RENESAS TECHNICAL UPDATE

Product Category	MPU & MCU	Document No.	TN-16C-A191A/E	Rev.	1.00
Title	Errata to R32C/117 Group Hardware Manual		Information Category	Technical Notification	
Applicable Product	R32C/117 Group	Lot No.	Reference Document	R32C/117 Group Hardware Manual Rev. 1.00 (REJ09B0533-0100)

This document describes corrections to the R32C/117 Group Hardware Manual, Rev. 1.00.
The corrections are indicated in red in the list below.

Figure 8.1 Clock Generation Circuitry

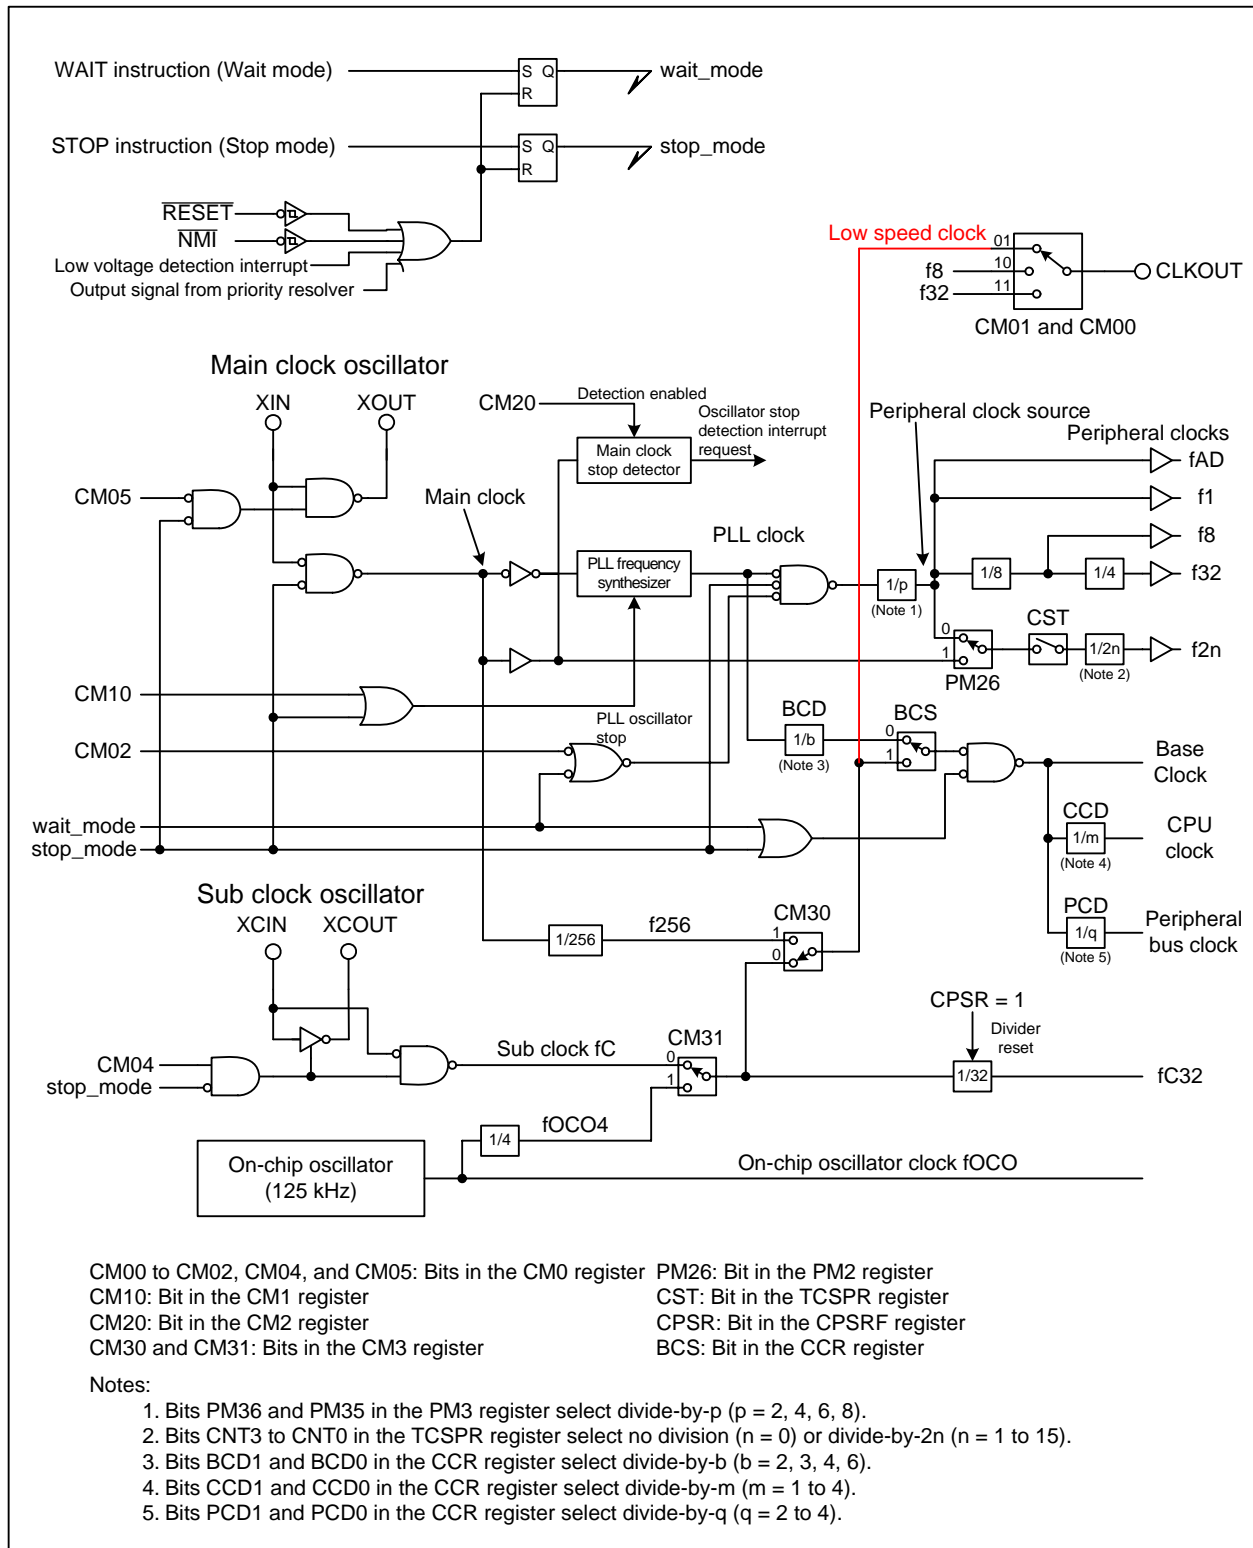
•Page 83 of 601, Figure 8.1 is corrected as follows:

Figure 8.19 State Transition (when the on-chip oscillator clock is used)

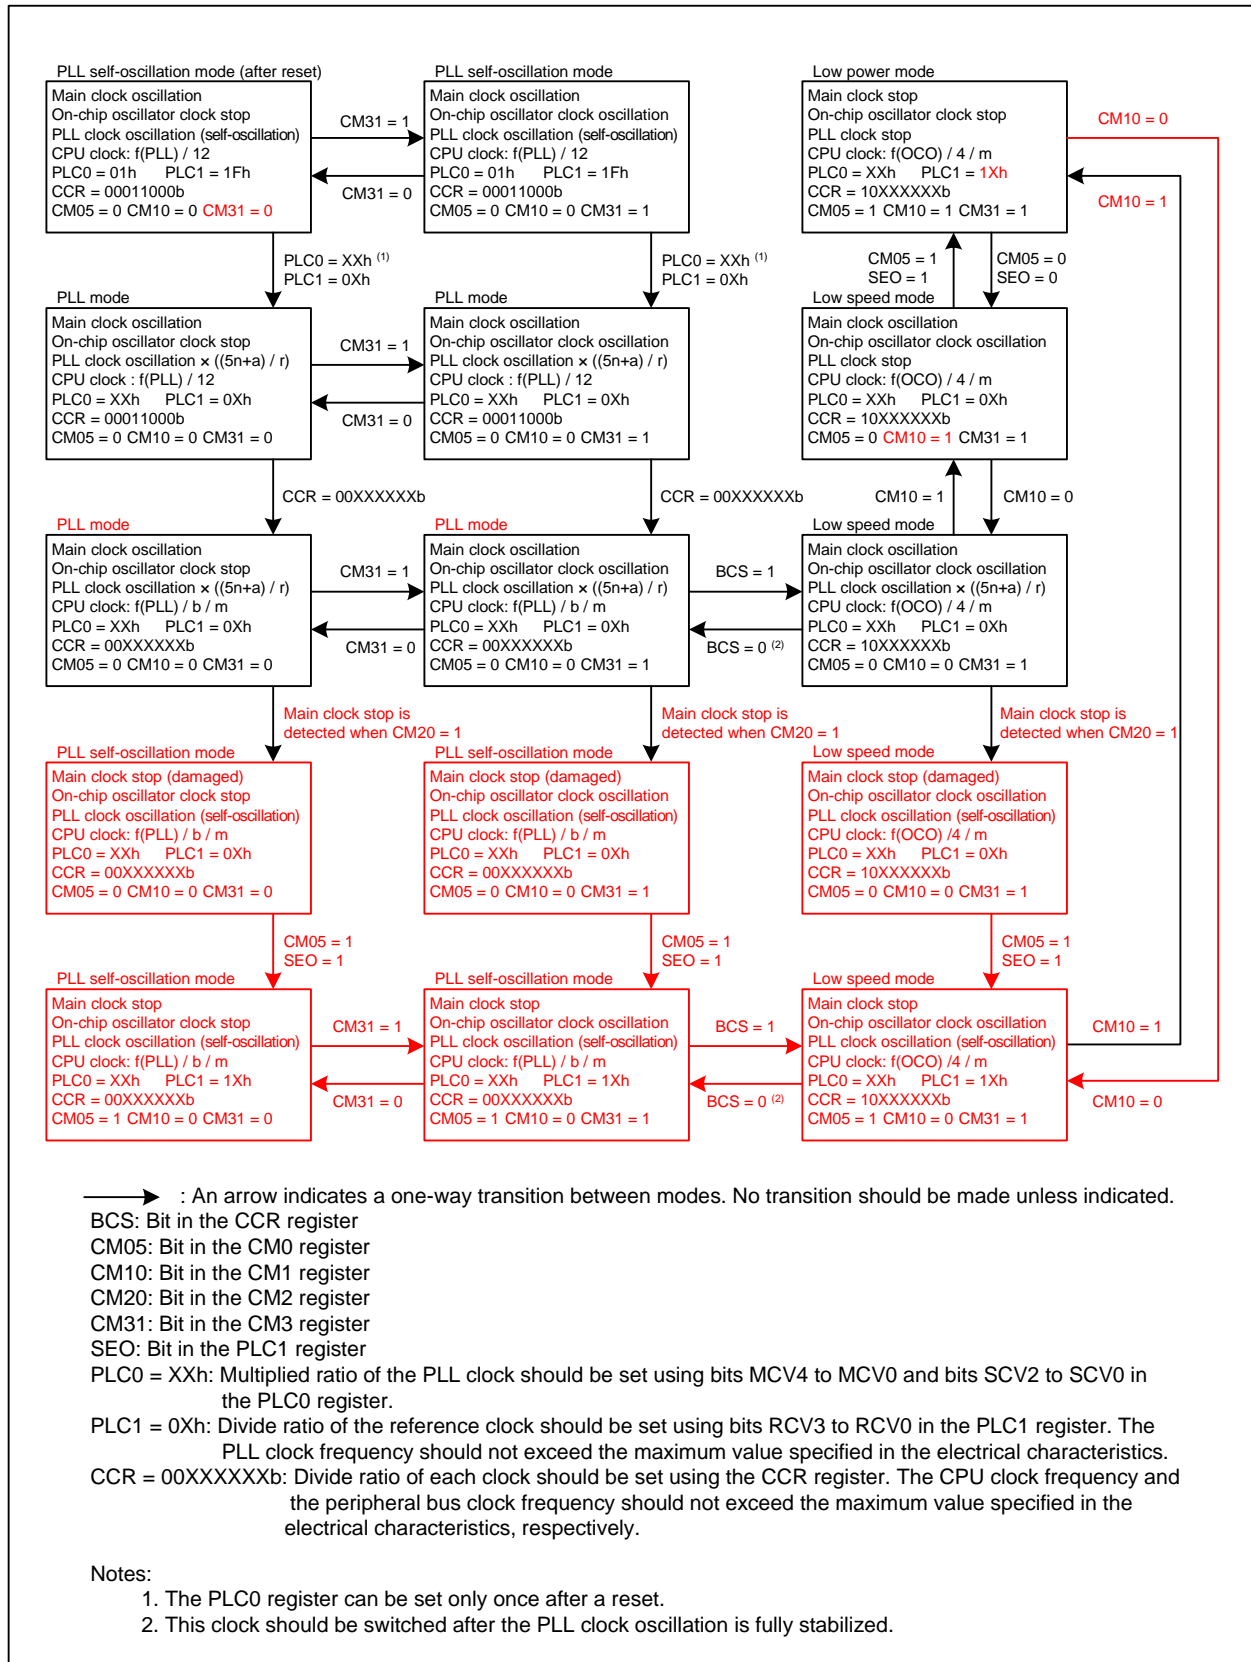
•Page 103 of 601, descriptions of “CM31 = 1” in the first row and “CM10 = 0” in the second row in Figure 8.19 are corrected, and the flowchart are clarified as follows:

(Note 3 “The CM05 bit is not set to 1 when an oscillator stop is detected through the oscillation stop detector.” is deleted from Figure 8.19)

Figure 9.15 ALE Signal and Address Bus/Data Bus

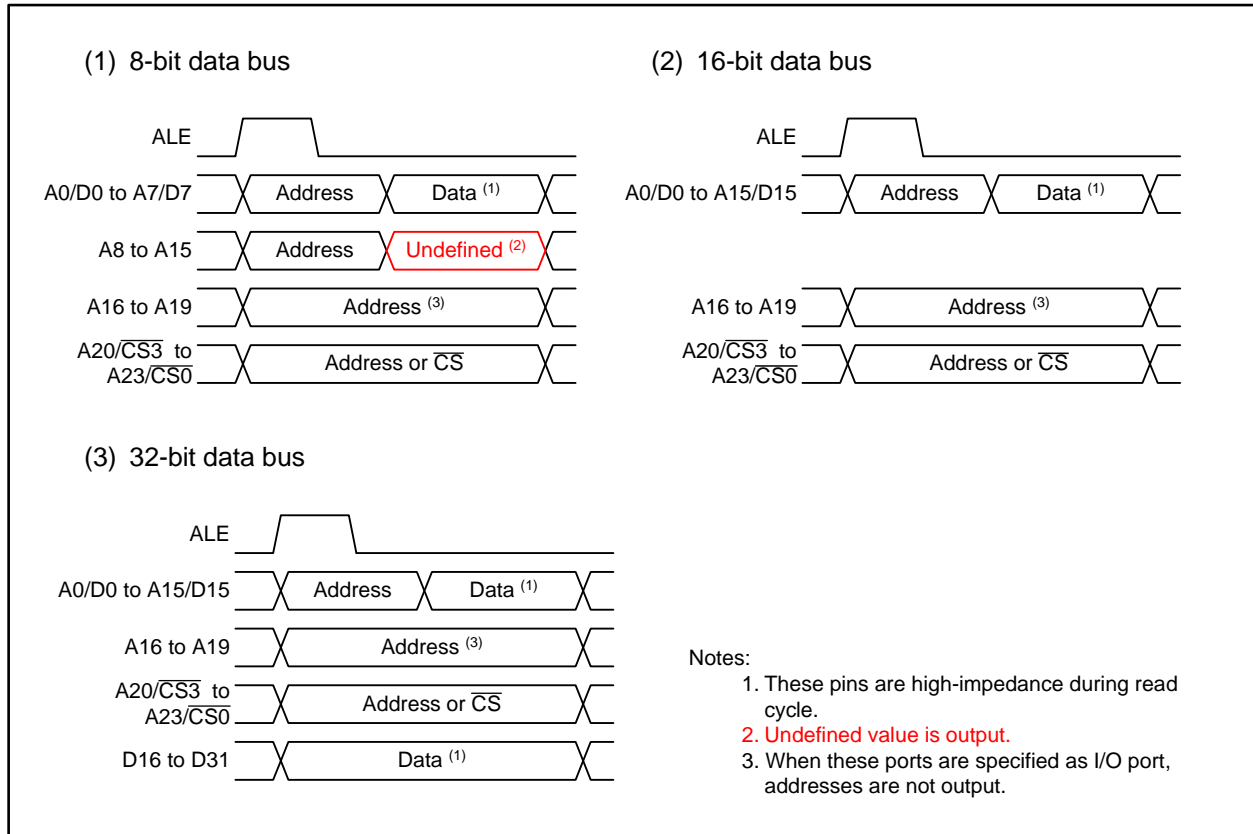
•Page 131 of 601, Figure 9.15 is corrected as follows:

Figure 11.8 Priority Resolver

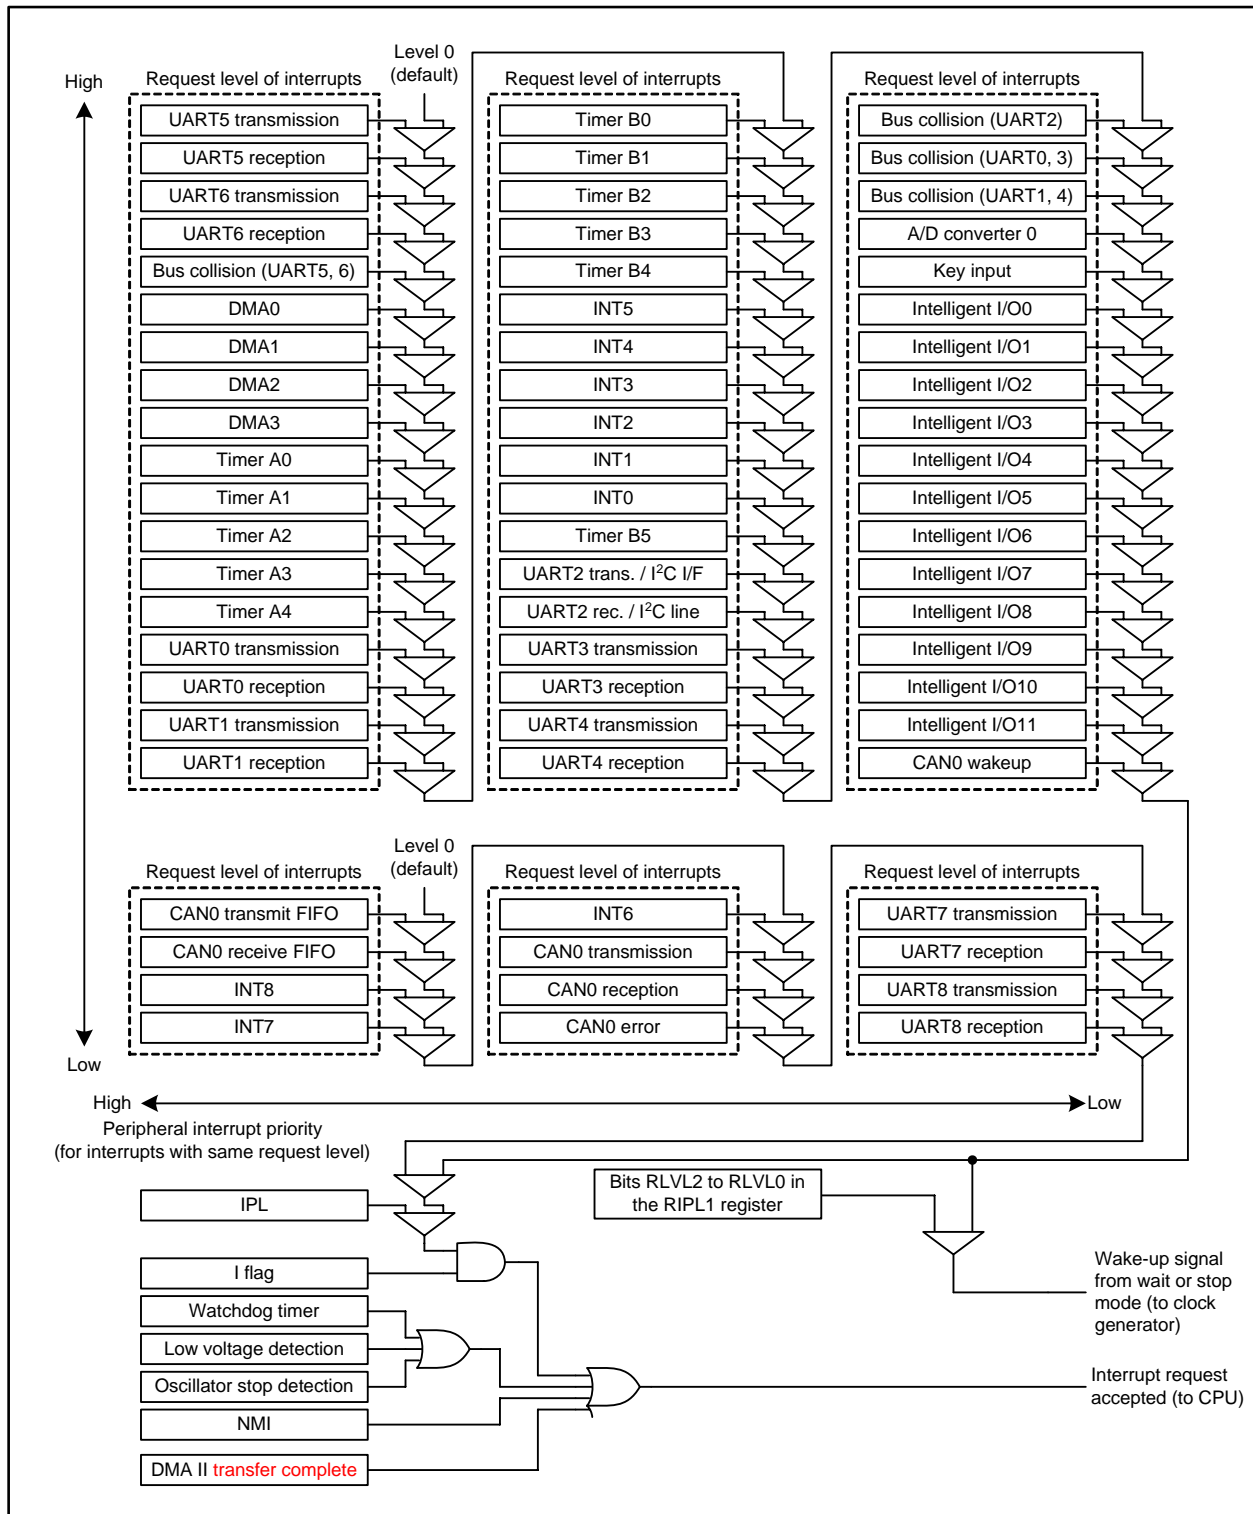
•Page 158 of 601, Figure 11.8 is corrected as follows:

(Description “Bits RLV2 to RLV0 in the RIPL2 register” and associated signal lines are deleted from Figure 11.8)

Figure 16.2 Timer B Configuration

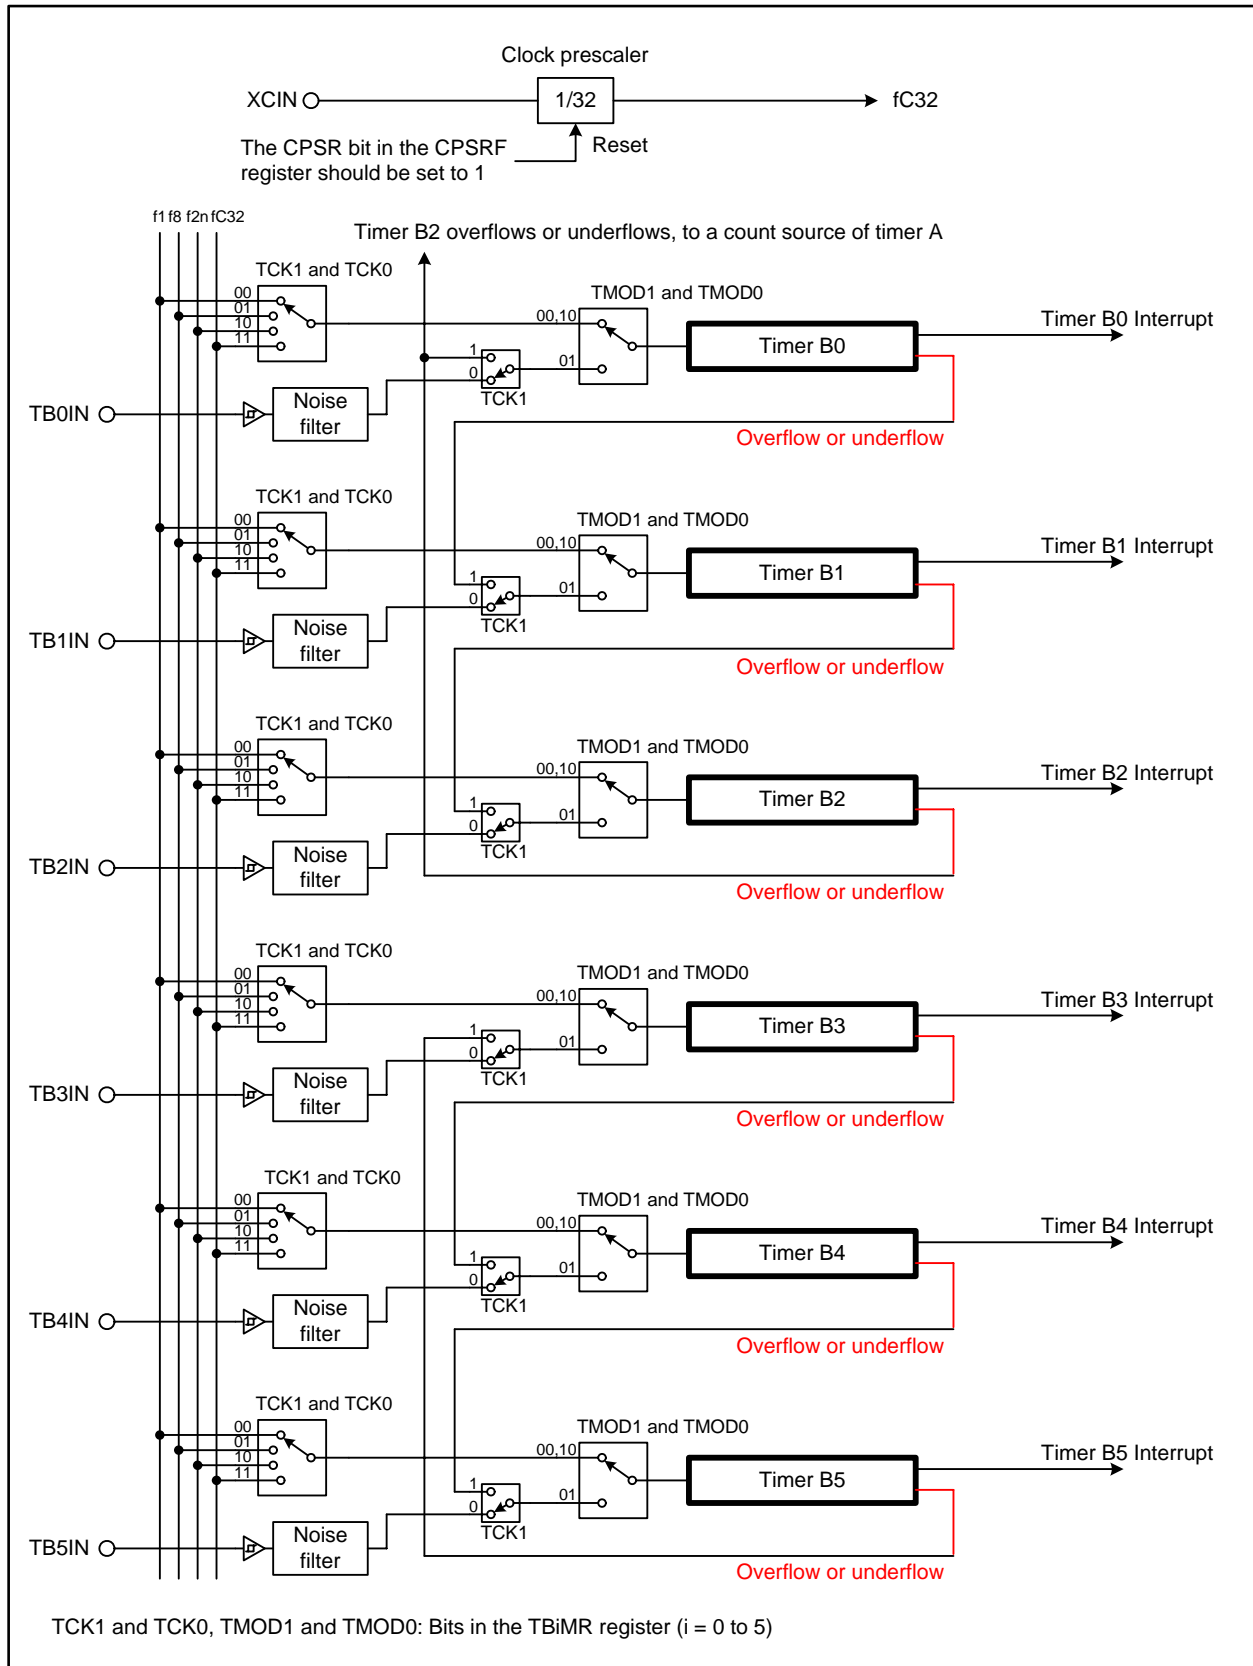
•Page 196 of 601, Figure 16.2 is corrected as follows:

Figure 27.13 Read Timing

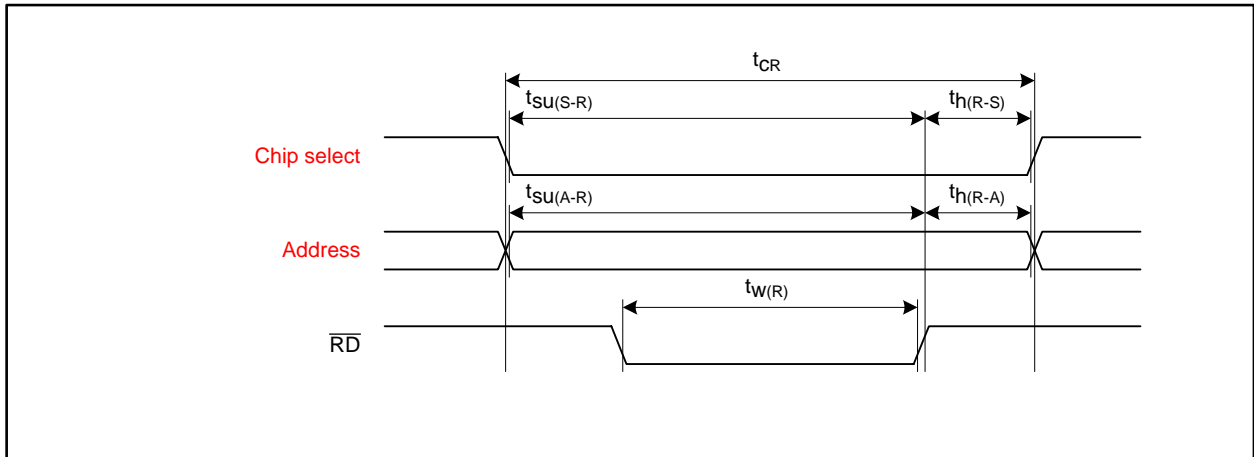
•Page 521 and 523 of 601, descriptions in Figures 27.13, 27.14, and 28.5 are corrected as follows:
